PETITION FOR CHANGE OF THE PROJECT DESCRIPTION IN THE FINAL DECISION TO EXPAND AN EXISTING SWITCH GEAR ENCLOSURE AT PALOMAR ENERGY CENTER (O1-AFC-24C)

SAN DIEGO GAS & ELECTRIC COMPANY SAN DIEGO, CALIFORNIA

November 15, 2011

SDG&E PALOMAR ENERGY CENTER SOUTH SWITCHGEAR PHOTO-SIMULATION 1 10/18/11

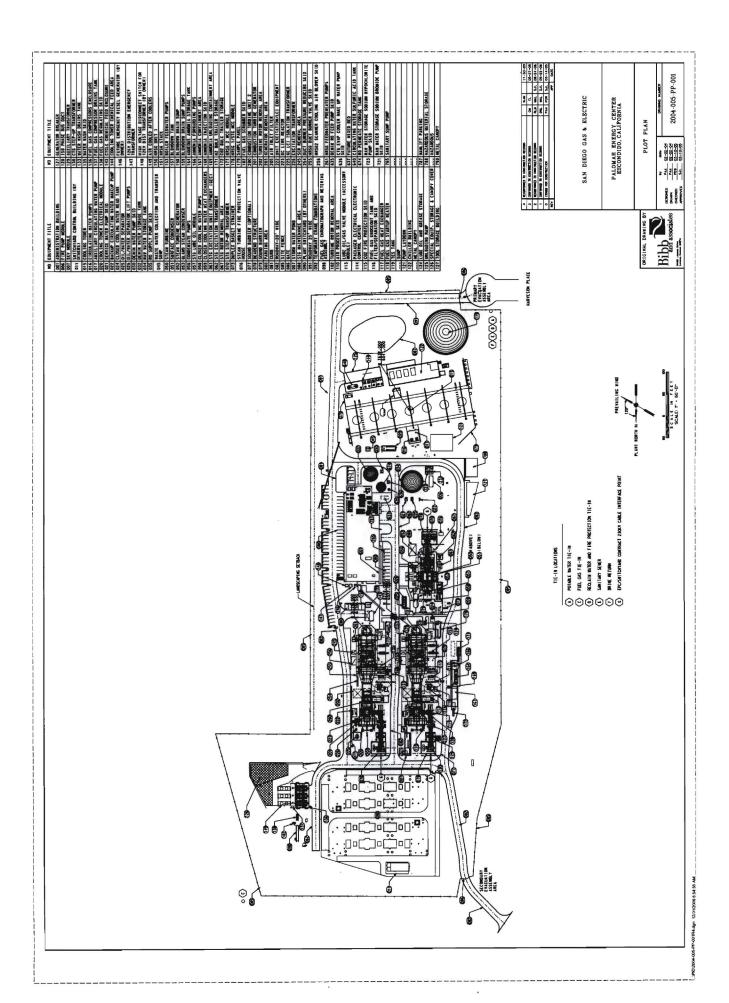
Cooling Tower Switch Gear Structure Improvement. SDG&E is proposing to add two 6'X22' expansions (one on each side of the building) to the existing switch gear enclosure. The expansion will improve lighting, improve access and location of electrical outlets, and improve access to equipment housed in the enclosure. The expansion will also be fitted with a 12'X8' roll-up door and a man door for accessibility to the housed equipment. The addition of the usable work space will ensure a safe working environment when performing maintenance, repairs, and/or inspections of the equipment. The outer surfaces of the building will be painted the plant color (SW 1022 Cubist grey). Plot plans showing the location of the building and visual simulations are attached in Appendix 1.
